# Work Order ID 114850

Item Name: Crosstube Turning Detail

DRAWING NO. D412-664-243	TITLE CROSSTUBE ASSEMBLY (412 HI AFT)	REV. E	<b>DART AEROSPACE LTD ENGINEERING ORDER</b>		D.E.O. NO. D412-664-243-E-4	SHEET NO. SHEET 1 OF 3	SCALE NTS
DRAWN <i>JP</i>	CHECKED <i>JP</i>	MFG. APPR. <i>JP</i>	APPROVED <i>JP</i>		DE APPR. <i>JP</i>		
DATE 12.08.21	DATE 12.08.30	DATE 12.08.30	DATE 12/8/30		DATE 12.08.30

**PURPOSE:**

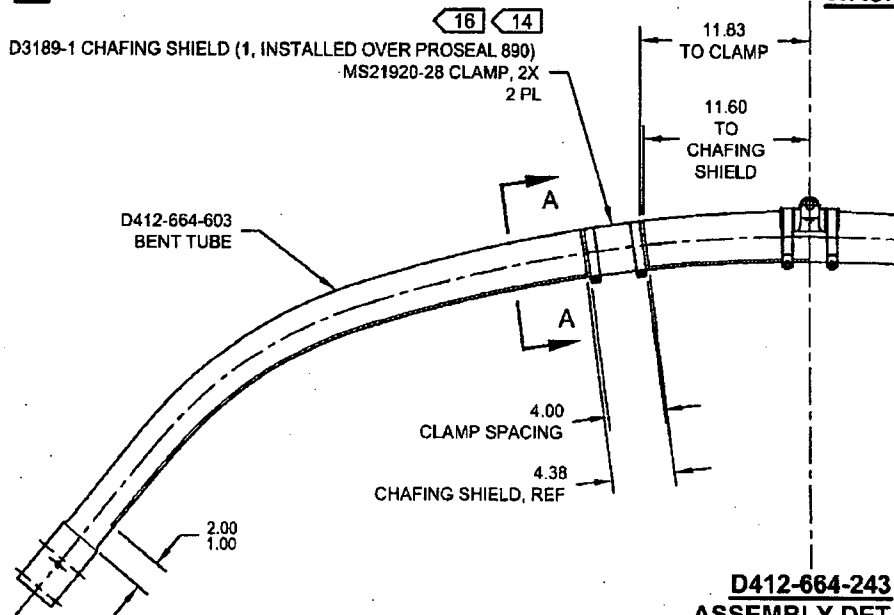
REMOVED ABRASION STRIP IN FAVOR OF A THIN LAYER OF PROSEAL 890. UPDATE INSTALLATION OF CHAFING SHIELDS AND REDUCE TORQUE TO 40-50 IN-LBS. THIS ENGINEERING ORDER SUPERCEDES DEO D412-664-243-E-1.

**PARTS LIST IS AMENDED AS FOLLOWS:**

**IS:**

Item	Qty -243	Part Number	Description
6	0	D2856-600-1009	ABRASION STRIP

**WAS:**

6	2	D2856-600-1009	ABRASION STRIP
---	---	----------------	----------------

**NOTES 2, 14, AND 16 ON SHEET 1 ARE AMENDED AS FOLLOWS:**

**IS:**

- 2) FINISH: CHEMICAL CONVERSION COAT PER DART QSI 005 4.1  
PRIME INSIDE AND OUTSIDE PER DART QSI 005 4.2  
MASK UNDERSIDE OF CROSSTUBE AS SHOWN (HATCHED AREA)  
PAINT OUTSIDE PER DART QSI 005 4.2  
AFTER PAINTING, APPLY CLEAR COAT ON HATCHED AREA
- 14) APPLY A THIN COAT OF PROSEAL 890 ON INSIDE CONCAVE SURFACE OF D3189-1 CHAFING SHIELD AND LET CURE PER MANUFACTURER'S INSTRUCTIONS. INSTALL PROSEALED D3189-1 CHAFING SHIELD ONTO CROSSTUBE BY APPLYING A THIN COAT OF PROSEAL 890 ONTO CROSSTUBE. BE SURE TO ELIMINATE ANY AIR GAPS.
- 16) TORQUE CLAMPS ON D2896-1 SUPPORT 80 TO 100 IN-LB. **TORQUE CLAMPS ON D3189-1 CHAFING SHIELD 40 TO 50 IN-LB.** ENSURE AT LEAST 1.5 THREADS SHOWING IN SAFETY AND THAT NUT HAS NOT BOTTOMED-OUT AFTER TORQUING.

**WAS:**

- 2) FINISH: CHEMICAL CONVERSION COAT PER DART QSI 005 4.1  
PRIME INSIDE AND OUTSIDE PER DART QSI 005 4.2  
PAINT OUTSIDE PER DART QSI 005 4.2
- 14) INSTALL D2856-600-1009 ABRASION STRIPS WITH A 0.13 REF GAP ON BOTTOM SIDE OF CROSSTUBE PER QSI 035.
- 16) TORQUE CLAMPS 80 TO 100 IN-LB. ENSURE AT LEAST 1.5 THREADS SHOWING IN SAFETY AND THAT NUT HAS NOT BOTTOMED-OUT AFTER TORQUING.

**D412-664-243  
ASSEMBLY DETAIL**

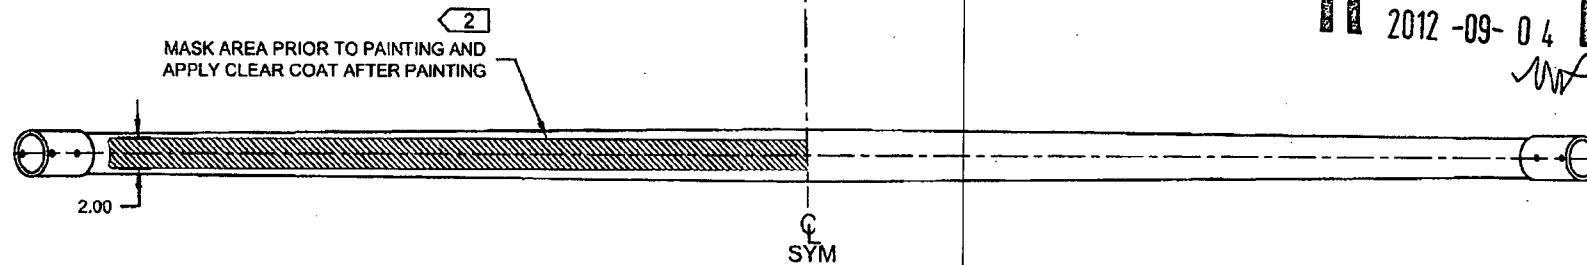
**IS:**

D3189-1 CHAFING SHIELD (1, INSTALLED OVER PROSEAL 890)  
MS21920-28 CLAMP, 2X  
2 PL

**WAS:**

D2856-600-1009 ABRASION STRIP  
D3189-1 CHAFING SHIELD (1, INSTALLED OVER ABRASION STRIP)  
MS21920-28 CLAMP, 2X  
2 PL

**SECTION A-A**  
CHAFING SHIELD DETAIL  
VIEW ROTATED, NOT TO SCALE

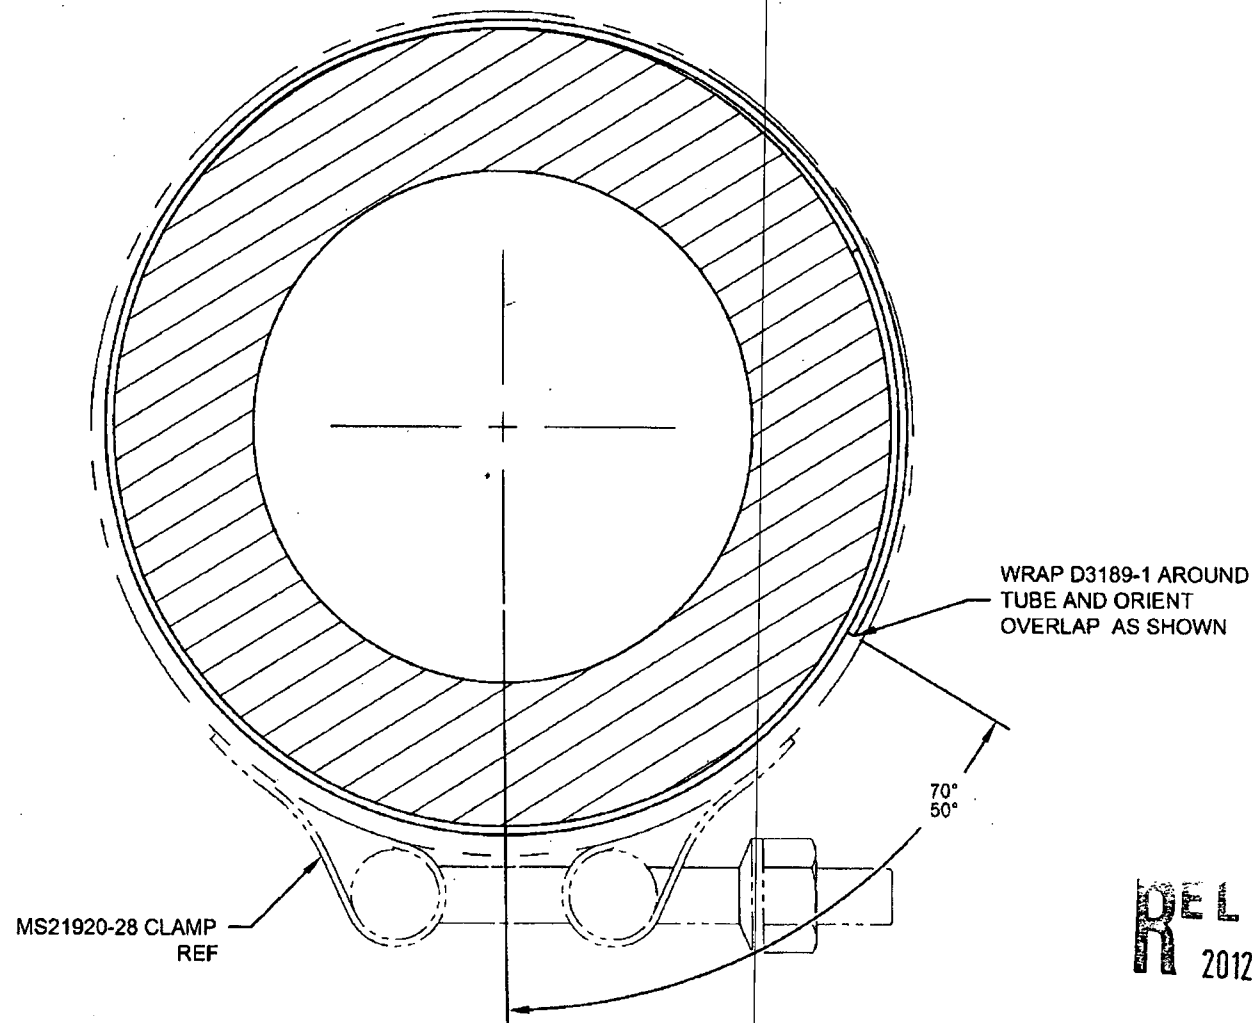
DRAWING NO. D412-664-243		TITLE CROSSTUBE ASSEMBLY (412 HI AFT)		REV. E	DART AEROSPACE LTD ENGINEERING ORDER		D.E.O. NO. D412-664-243-E-4	SHEET NO. SHEET 3 OF 3	SCALE NTS
DRAWN <i>MP</i>		CHECKED <i>MP</i>		MFG. APPR. <i>MP</i>		APPROVED <i>MP</i>		DE APPR. <i>MP</i>	
DATE 12.08.21		DATE 12.08.21		DATE 12.08.21		DATE 12.08.21		DATE 12.08.21
